TOWN OF FAIRFAX STAFF REPORT

TO: Fairfax Planning Commission
DATE: February 21, 2013
FROM: Jim Moore, Director of Planning and Building Services
 Linda Neal, Senior Planner
LOCATION: 305 Scenic Road; Assessor's Parcel No. 001-052-07
PROJECT: Mechanical/equipment/storage area
ACTION: Modification of approved Hill Area Residential Development and Design Review permits and Height Variance; Application # 10-28
APPLICANT: Michael and Marjorie McLennan
OWNER: Same
CEQA STATUS: Categorically exempt section 15301(e)

305 SCENIC ROAD

SITE PLAN - ORIGINAL HOUSE
AND TOPOGRAPHY

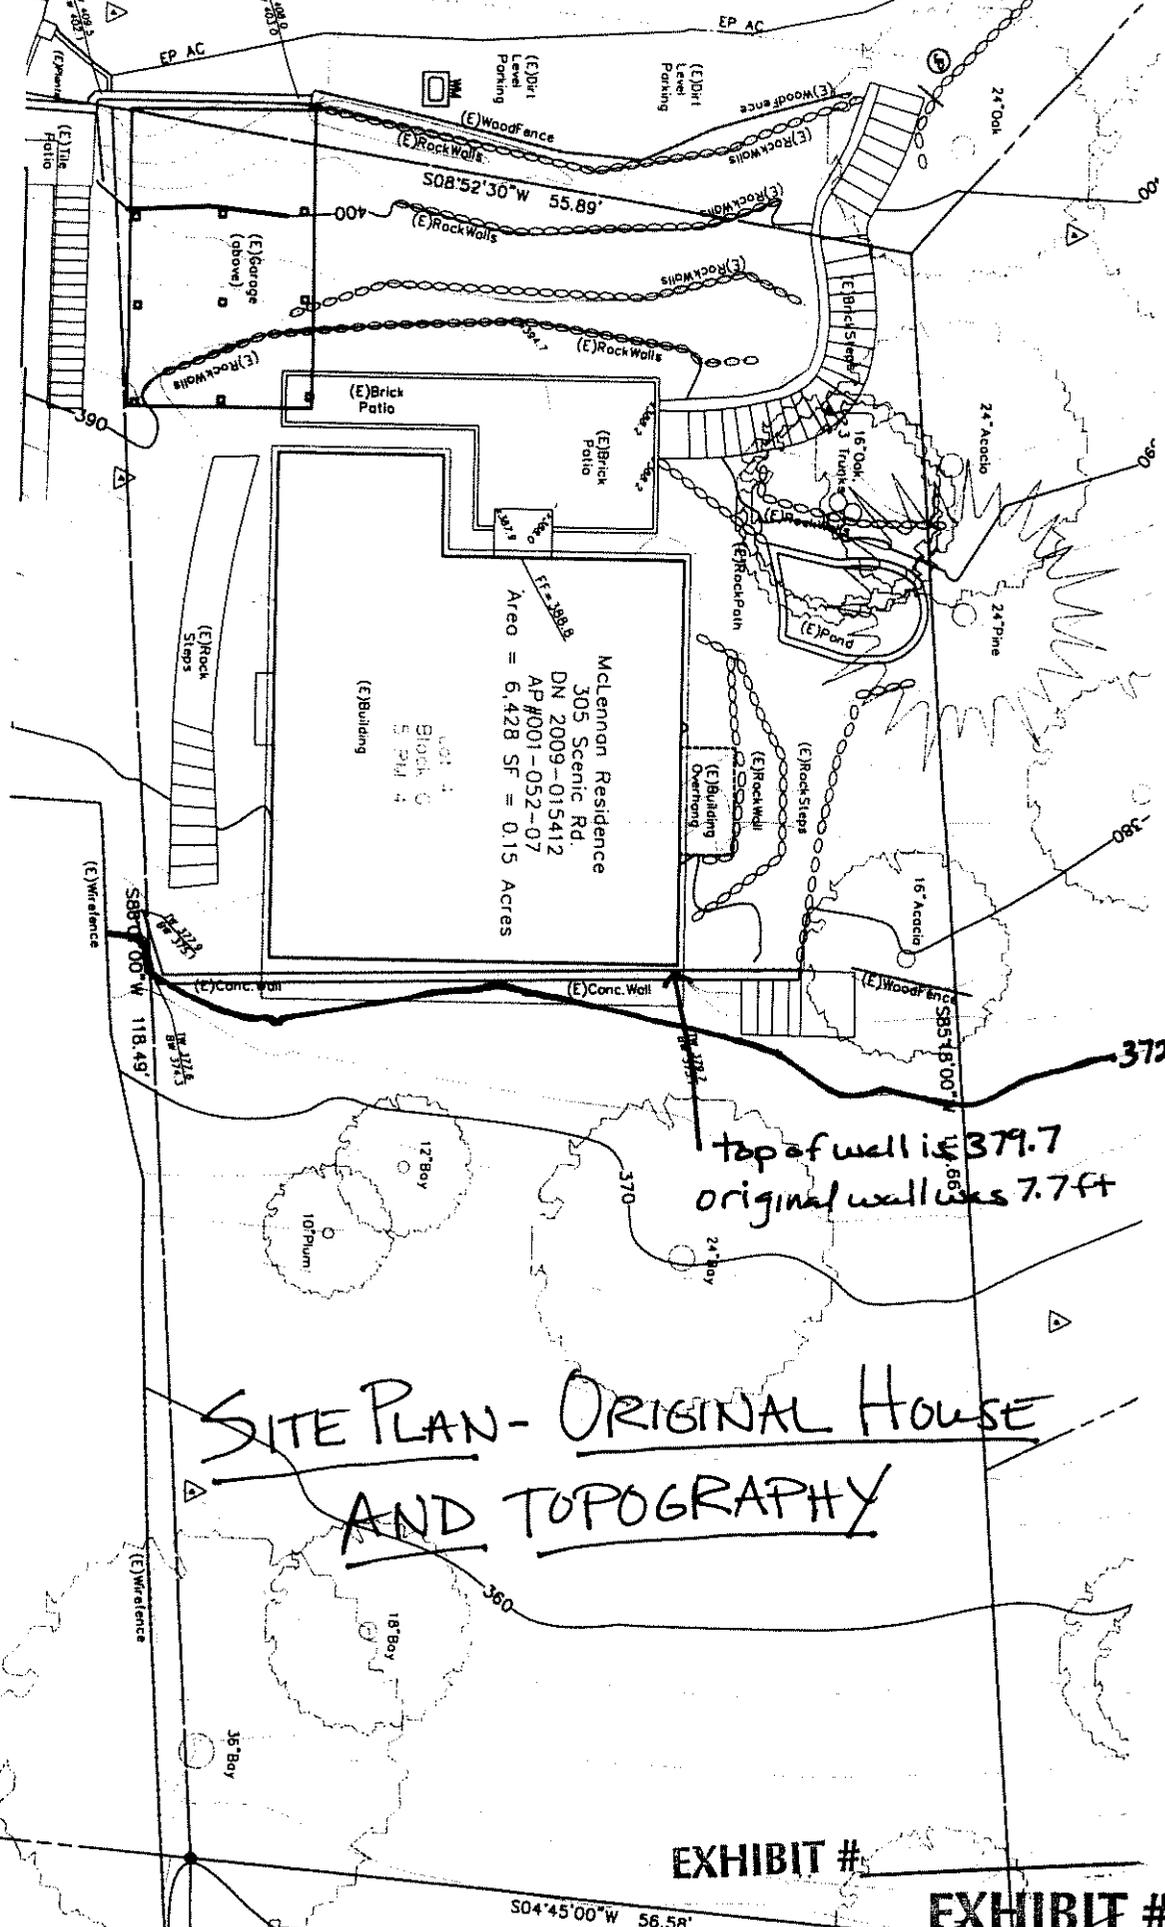
The 6,410 square foot site is 55.89 feet wide and slopes down from Scenic Road at a rate of 57%. It was previously developed with a condemned 1,397 square foot residence that was constructed in 1920. There was also previously a one car garage on the property. A collapsing retaining wall holding up the public road in the area of the garage was replaced in 1986. The dilapidated garage was demolished in 2005 after the Town began receiving complaints from the neighbors. The site was presumably graded with a large retaining wall below the original structure in the 1920's when the site was first developed (Exhibit B – Site plan and topography of original cottage).

Directly below the previously existing cabin was a 7 foot 7 inch retaining wall and it appeared that the wall had been in that location and the site had been graded for many years, possibly since the original construction of the residence (exhibit B).
